**MONTGOMERY COUNTY HISTORIC PRESERVATION COMMISSION**  
**STAFF REPORT**

<b>Address:</b>	7312 Carroll Avenue, Takoma Park	<b>Meeting Date:</b>	3/26/2025
<b>Resource:</b>	Contributing Resource <b>Takoma Park Historic District</b>	<b>Report Date:</b>	3/19/2025
<b>Applicant:</b>	Richardson School of Music (Maria Wright, Architect)	<b>Public Notice:</b>	3/12/2025
<b>Review:</b>	HAWP	<b>Tax Credit:</b>	Partial
<b>Permit Number:</b>	1107109	<b>Staff:</b>	Devon Murtha
<b>Proposal:</b>	Partial demolition and window replacement, door replacement, gutter installation, and other alterations, and retroactive window replacement on facade.

7312 CARROLL AVE  
RENOVATION

Figure 5: North elevation of subject property (Applicant, 2025). The existing wood windows are annotated with red boxes.

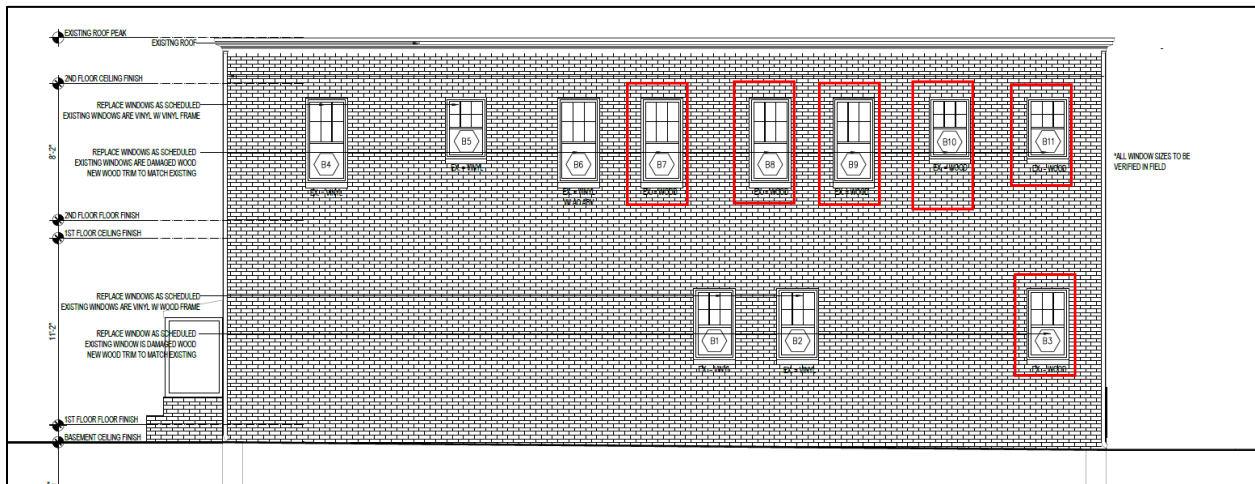
Of the eleven (11) windows on the right elevation, six (6) are historic wood sash windows and five (5) are vinyl. The existing wood windows are in poor condition, based on Staff’s observation from a site visit and photos submitted by the applicant. Notably, the applicant has not submitted a complete window survey showing the dimensions of the existing windows and their specific conditions. Three of the windows are boarded up from the inside and are inaccessible.

The applicant is proposing to replace all eleven (11) windows on this elevation with double-hung aluminum-clad wood windows in the existing window openings. The applicant is proposing to install 6/1 Pella Reserve Traditional Windows with simulated divided lights to closely match the appearance of the original wood windows. The proposed aluminum-clad brickmold will closely match the existing profile of the historic brickmold. The proposed windows jambs will be inset to replicate the depth of the historic wood windows.

The applicant proposes to install eleven (11) aluminum-clad wood windows and frames into the existing window openings on the north/right side elevation. Staff finds that, based on observations from an exterior-only site visit, and a selection of photos submitted by the applicant, the existing wood windows and frames are in extremely poor condition and cannot reasonably be repaired. In keeping with *Standard 6*, deteriorated features that cannot be repaired will be replaced with new feature to closely match the appearance of historic features. Staff will require the applicant to submit a more detailed window survey to confirm the condition of each window, to comply with the pictorial documentation clause in *Standard 6*.

1. The applicant will submit a complete window survey to confirm the following:
  - a. That the historic wood windows are not salvageable
  - b. The dimensions of the existing windows, specifically the muntin profile
  - c. The inset depth of the jamb
2. Original wood windows in good condition will not be permitted to be removed. If windows are found in good condition, they must be retained in their location or reinstalled on the façade.
3. This approval does not extend to any work on the façade. The existing vinyl windows on the façade may not be replaced in-kind with new vinyl windows, and any new replacement must return to the HPC for a HAWP.
4. The gutters and downspouts must be painted a neutral color.
5. The applicant must submit mortar specifications and a brick sample to demonstrate compatibility with the adjacent wall for the proposed window infill on the rear elevation.

Figure 6: New aluminum clad window schedule (left) and grill specification (right).

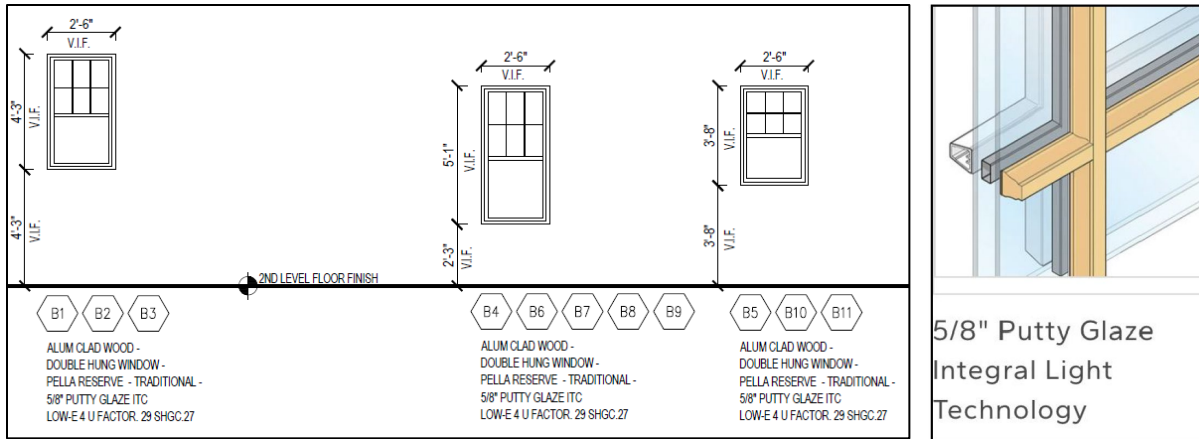
Staff also reviewed the proposal against the specific guidelines for commercial properties in Takoma Park, in *Appendix B* of the *Guidelines*, and finds that the aluminum-clad replacement windows are appropriate. Presently, the windows on the north/right elevation are not of a matching design, as they are a mix of wood and vinyl windows, as well as 1/1 and 6/1 sashes. The replacement of both the wood and vinyl windows with aluminum-clad windows to replicate the appearance of historic wood will restore consistency to this elevation, per the *Appendix B* guidance that windows be of a matching design on a single elevation. The replacement of the existing 1/1 vinyl windows with aluminum clad wood windows that more closely match the historic profile of the original windows is certainly an improvement. Further, *Appendix B* permits the use of metal-clad replacement materials, including the aluminum-clad wood windows. The proposed Pella Reserve windows have an acceptable integral color and are double glazed, per *Appendix B*.

Staff recommends that the HPC approve the proposed windows or windows with comparable details, with final approval authority delegated to staff. Due to the poor condition of the building, the applicant has not been able to provide a comprehensive window survey. Staff notes that this approval is contingent upon the applicant demonstrating that the windows are not salvageable. Wood windows in good condition will not be permitted to be removed, although they may be permitted to be reinstalled on the façade with Staff approval.

Figure 9: Rear elevation of subject property, showing the anticipated conditions inside the frame addition (left) and existing door opening on the first story (right).

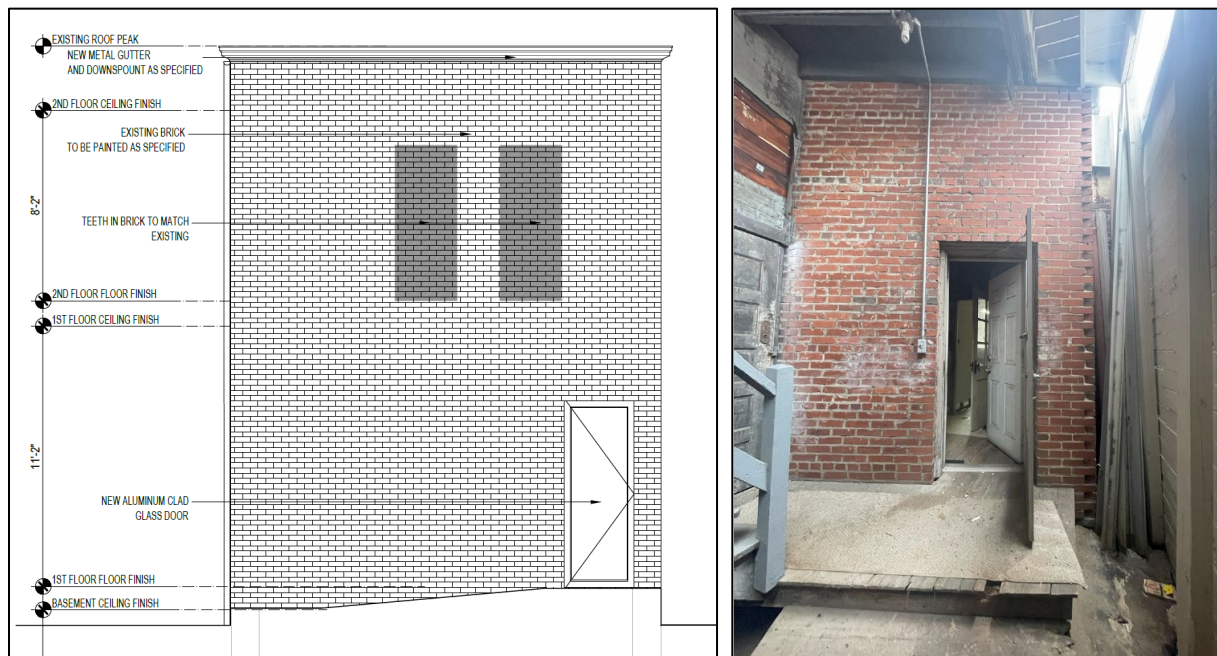
The applicant worked with a structural engineer's to confirm that the frame addition is unsafe and needs to be removed for occupancy. On the first floor, the applicant is proposing to remove the existing wood paneled door and replace it with a new entry that will hold a single-leaf aluminum clad glass door. On the second floor, the applicant is proposing to infill two existing door openings with brick to match the surrounding historic brick (Figure 9).

Staff finds that the alterations to the rear of the building, including the removal of the frame addition, the infill of two second-story openings, and the replacement of the first-story door, are appropriate. The existing frame structure is a hazard and presents a barrier to rehabilitation. The rear of the building is not at all visible from the public right-of-way, and alterations should be approved as a matter of course, per the *Guidelines*. In accordance with *Appendix B*, openings that face out onto alleyways and rear areas may be closed with materials and a design that matches or is compatible with the material design and finish of the adjacent wall. Staff recommends that the applicant submit mortar specifications and a brick sample to demonstrate compatibility with the adjacent wall.

3 NORTH ELEVATION  
A200 1/4" = 1'-0"

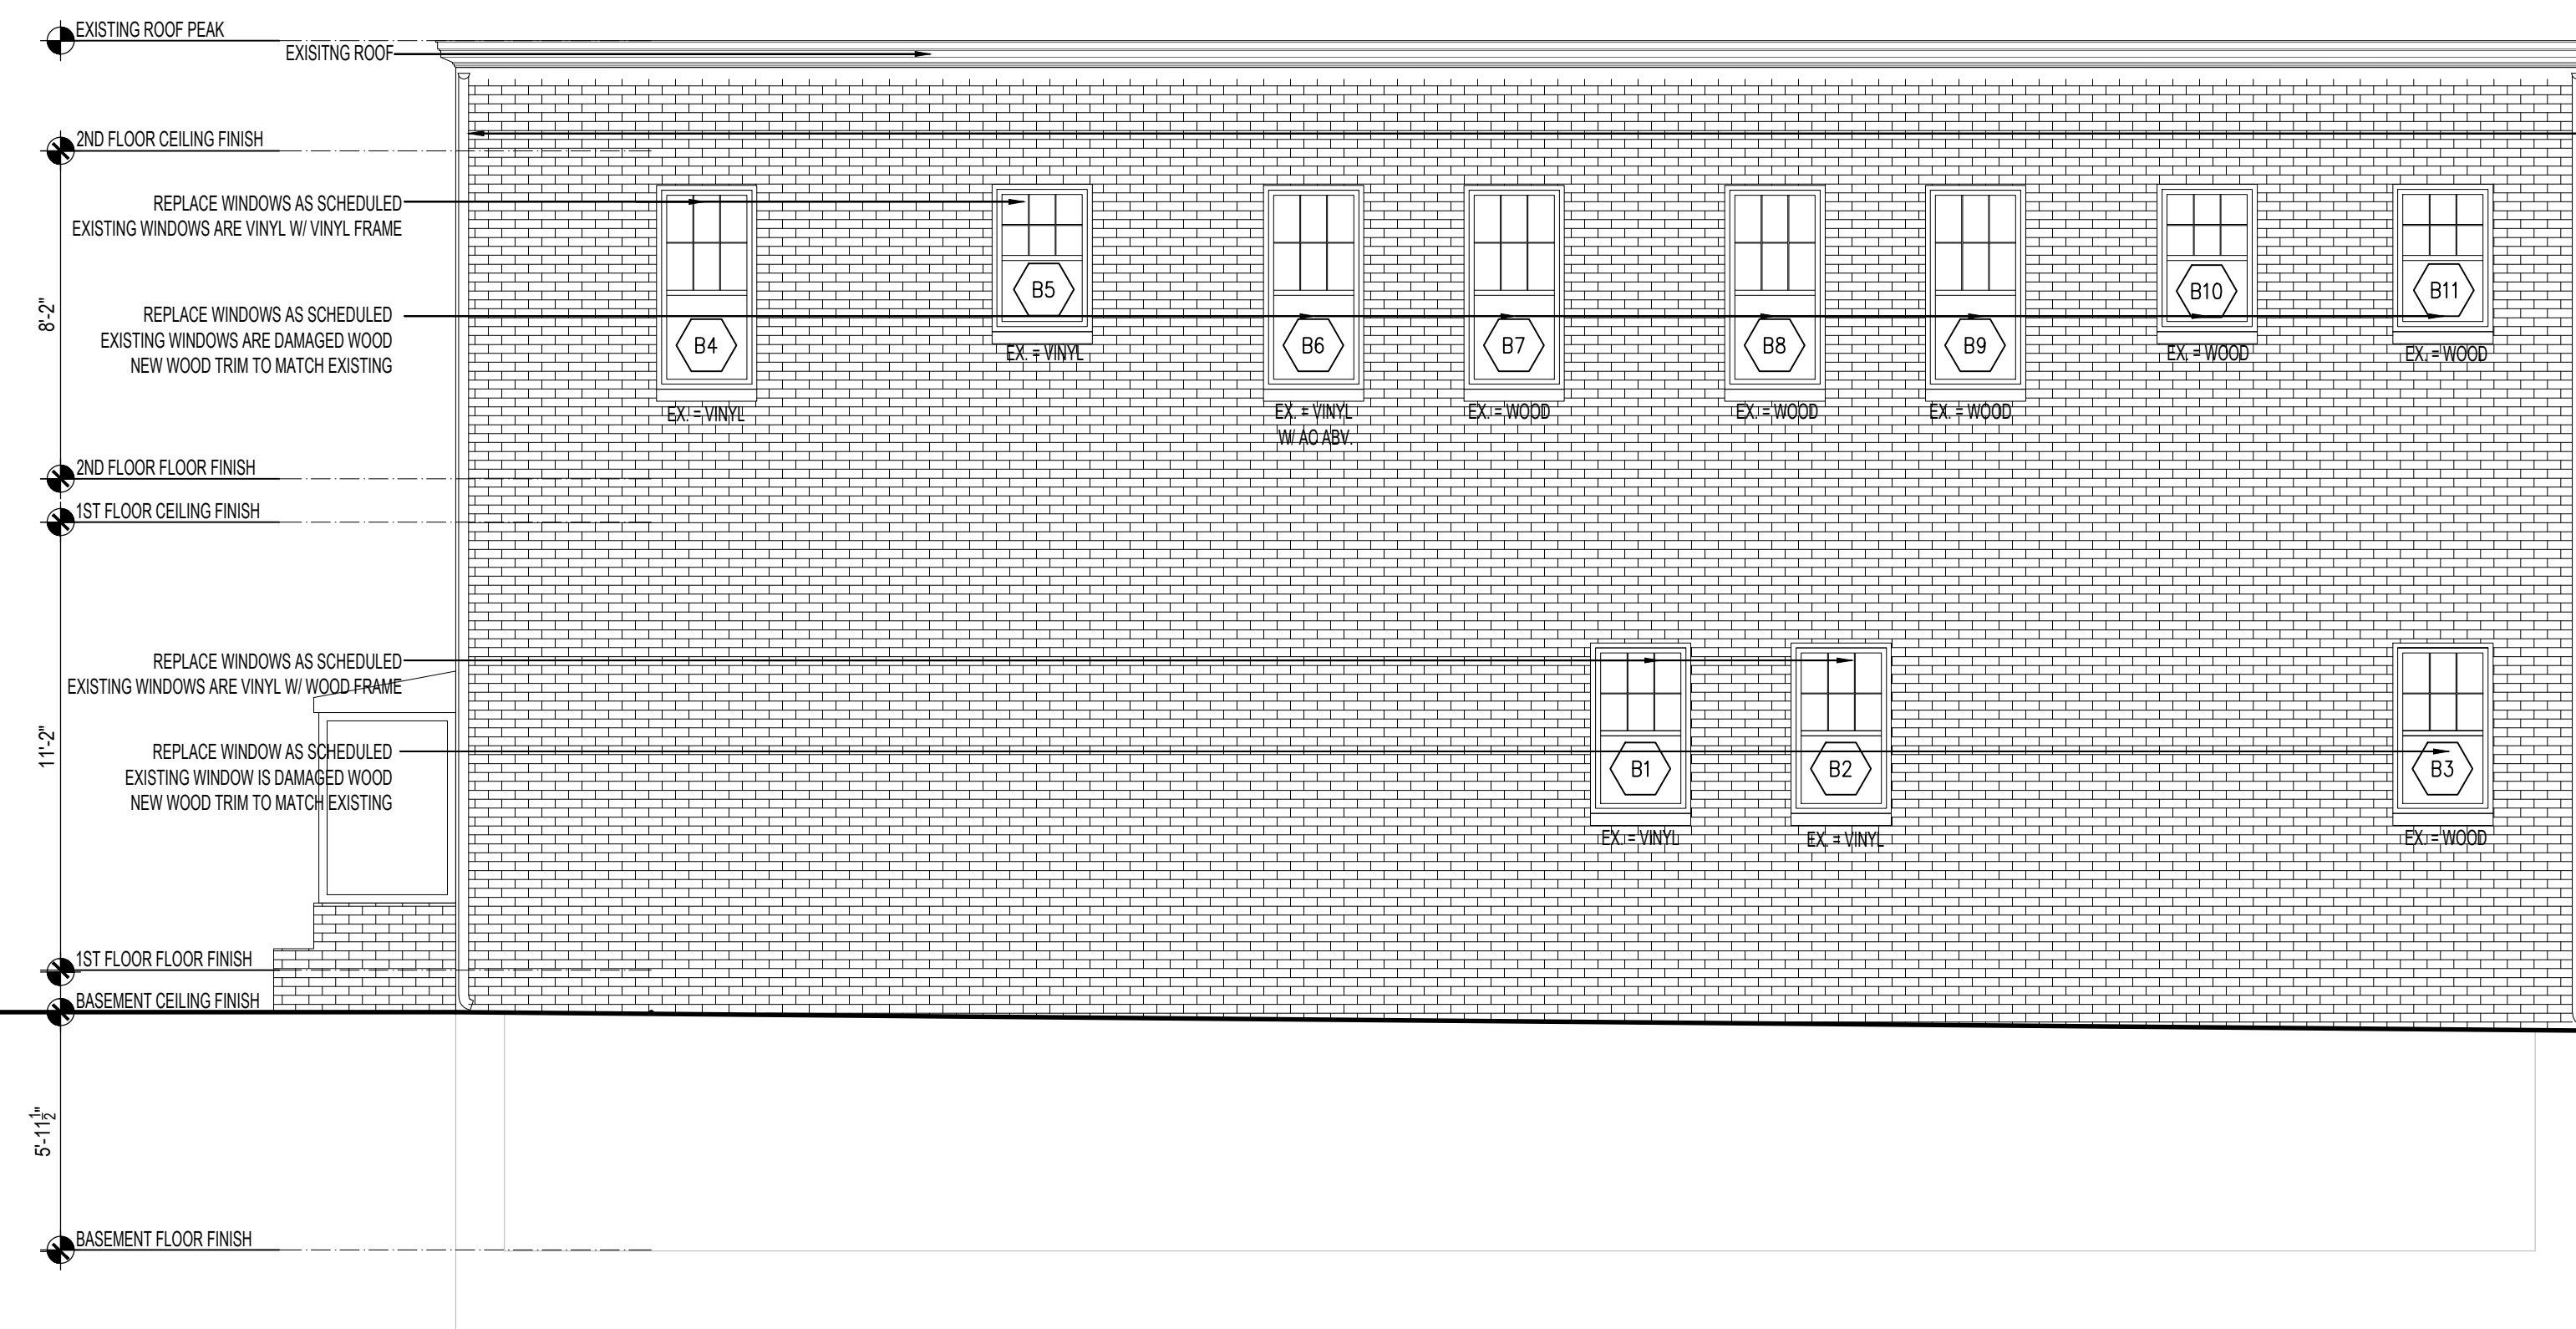
Taking into account the hierarchy of elevations and impact on the streetscape, Staff finds that aluminum-clad windows, as opposed to traditional wood windows, are appropriate replacements *in this particular case*. The existing wood windows are located on a secondary elevation and are minimally visible from the public right-of-way (*Figure 11*). Staff also considered the narrow width of the private alley in this assessment. The view from the public right-of-way is at such an acute angle that it obscures the specific material profile of the rear windows (*Figure 11*).

The *Guidelines* further emphasize the need to retain the shape and size of window openings and, *where feasible*, the maintenance of original windows, particularly those with specific architectural importance. The applicant's proposal to retain the original size and shape of the openings satisfies this criterion. In the absence of salvageable original material (as is the case here), the architectural importance of the windows rests largely on the rhythm of the openings, and not specific material qualities of the windows. The primary visual characteristics of the windows, as viewed from the public right-of-way, include the pattern of their

arrangement along the elevation and the depth of recession into the window opening. The applicant proposes to maintain the window openings and match the historic jamb depth, therefore satisfying this condition.
